Agenda
City of Springboro Planning Commission Meeting
Wednesday, March 13, 2024, 6:00 p.m.
Council Chambers, City Building, 320 West Central Avenue

Record Plan, Village Park PUD-MU, Planned Unit Development-Mixed Use, office component, replat of Clearcreek Township Fire Station #24 site

Site Plan Review, southwest terminus of West Tech Boulevard, new building for Caesar Creek Software

Final Development Plan, 1525 South Main Street (SR 741), Northampton PUD-R, Planned Unit Development-Residential, residential subdivision

SHEET NUMBER
2 OF 12

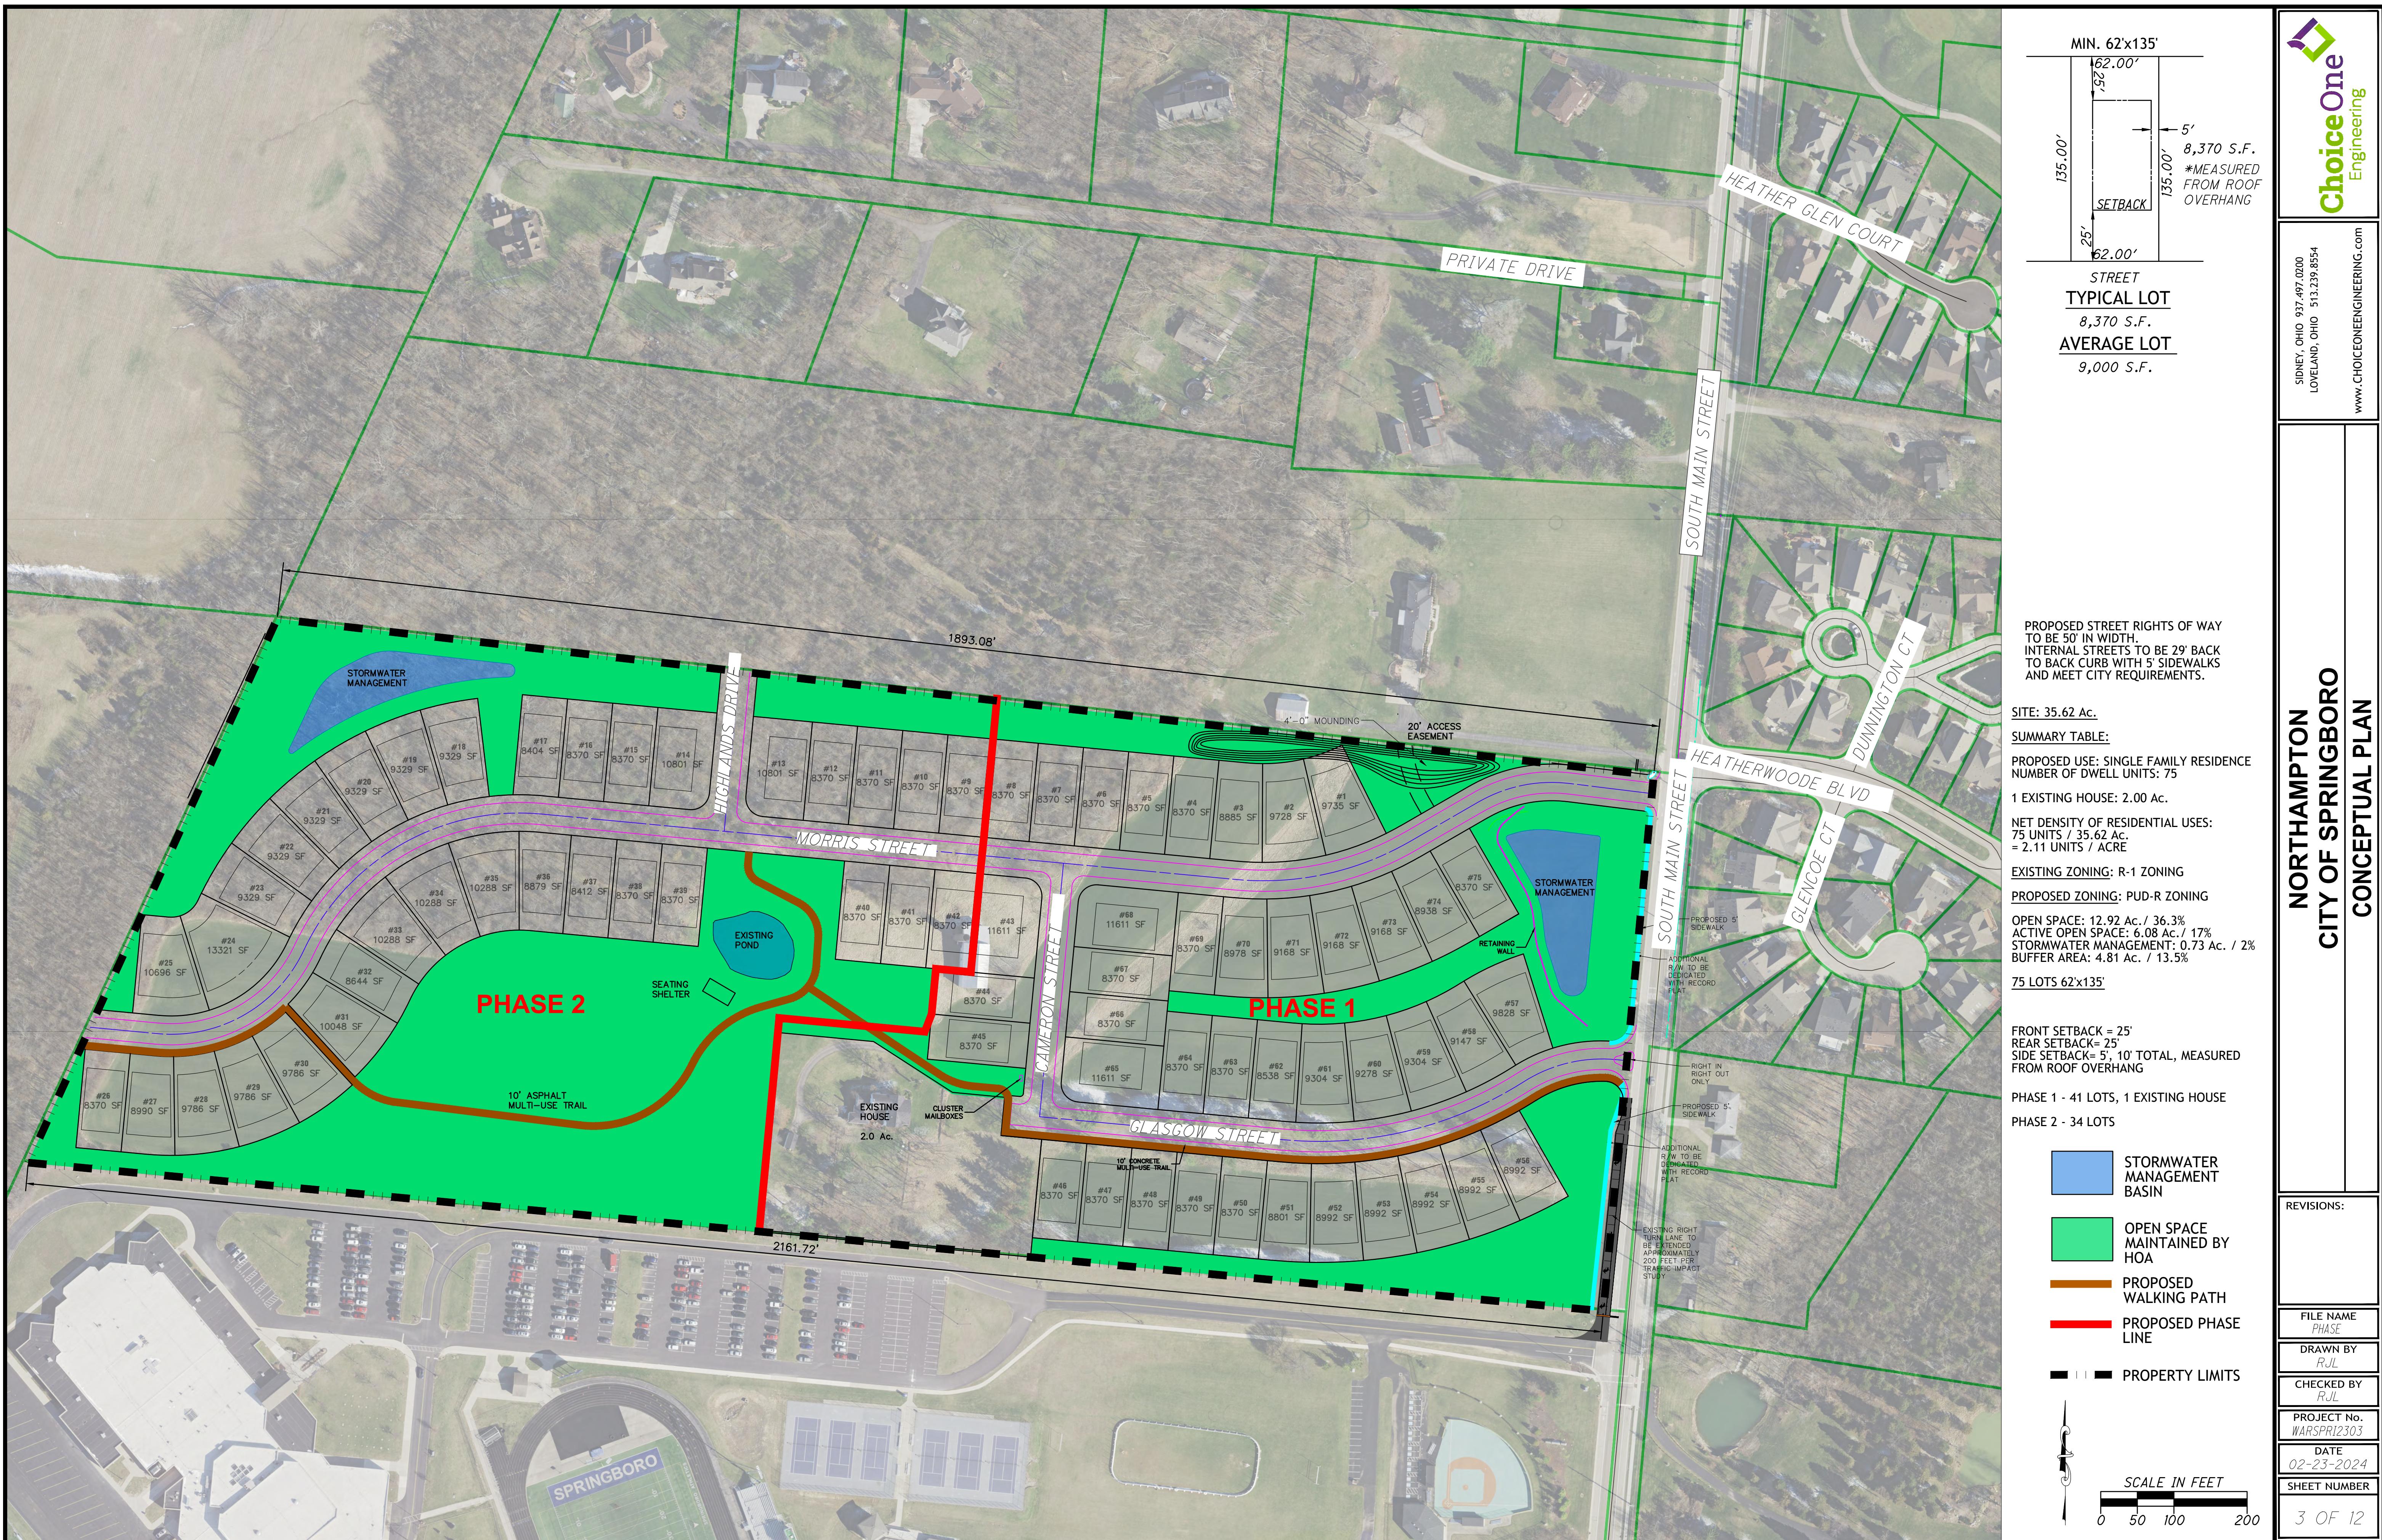
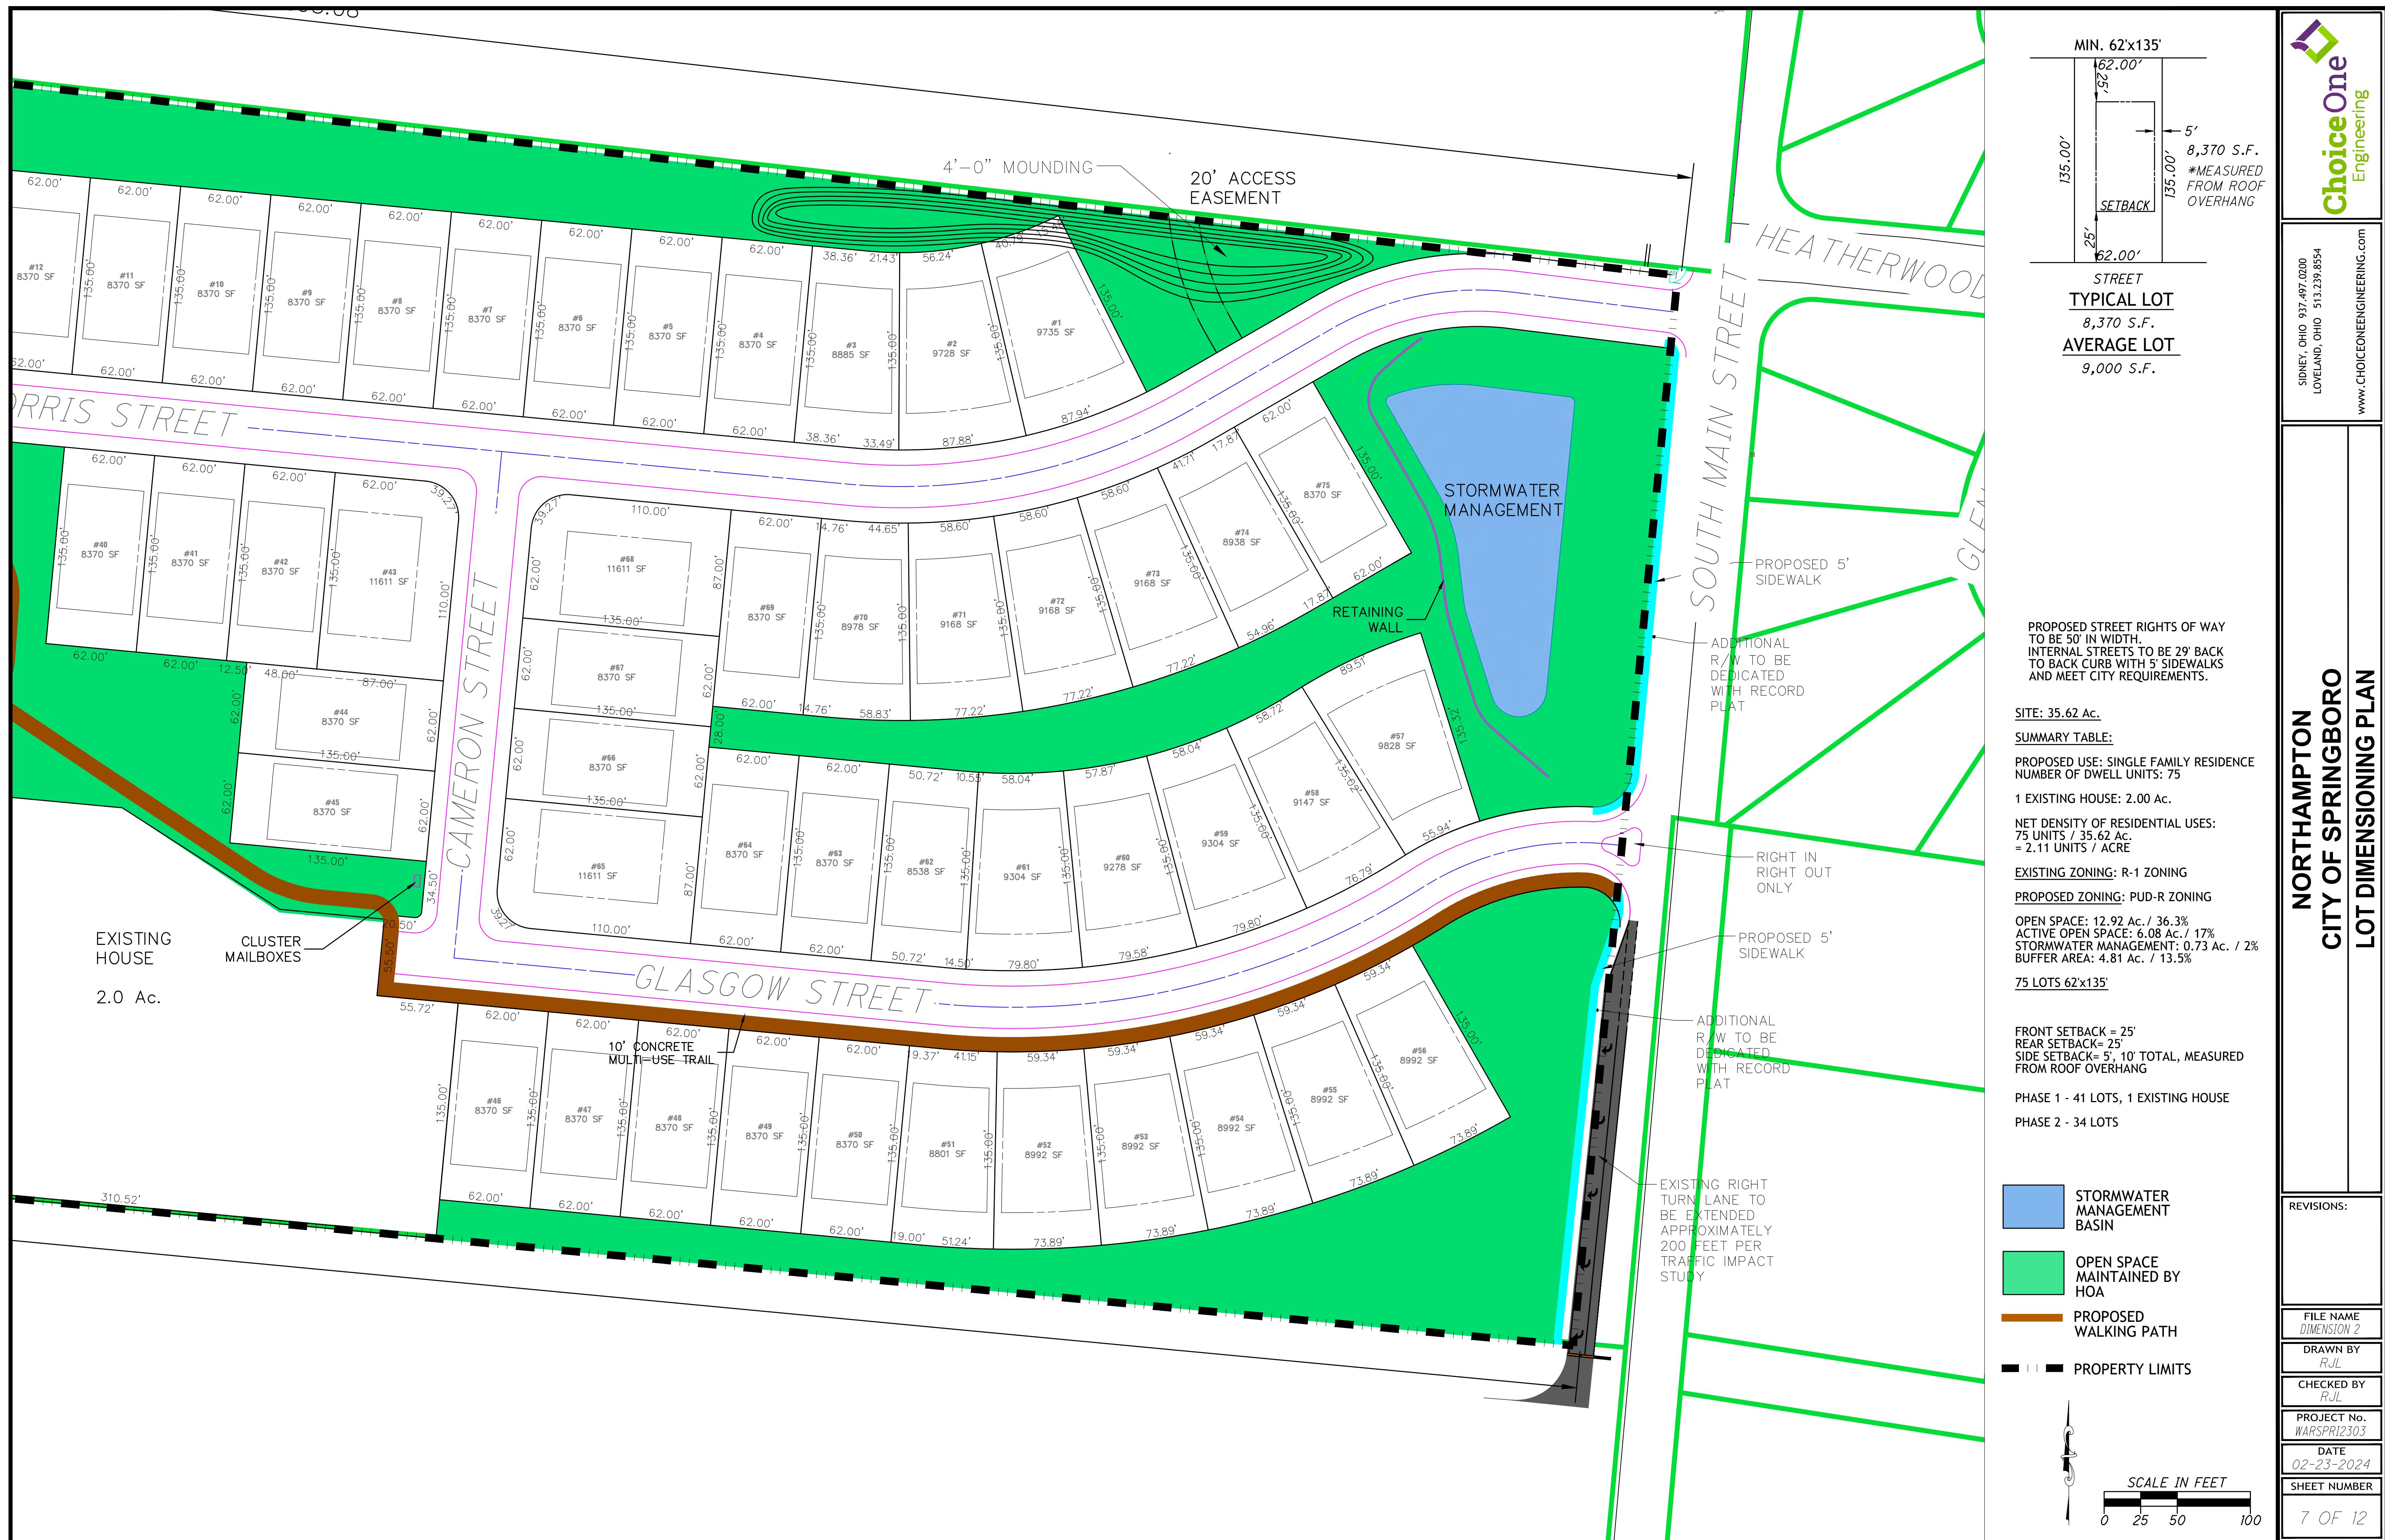
1. Check open space information provided on sheet 4 of 12; total is less than approved general plan, and the numbers do not add up correctly.
2. All homes to be consistent with Section 1264.06, Development Standards for Specific Uses, Single-Family Dwellings (Detached) for compliance of some of the home plans with (b) Appearance, and (c) Garages with respect to 60% maximum width and side/rear access.
3. Landscaping plan information needs to be updated as follows to assist in staff's review under Chapter 1280, Landscaping, of the Planning and Zoning Code:
 - a. Indicate how required buffers are to be memorialized and maintained.

- 16. Is the fence on the south property line remaining in place?
- 17. Provide minimum dwelling unit floor area and minimum lot size (change from typical) and delete average lot on general plan sheet 4 of 12.
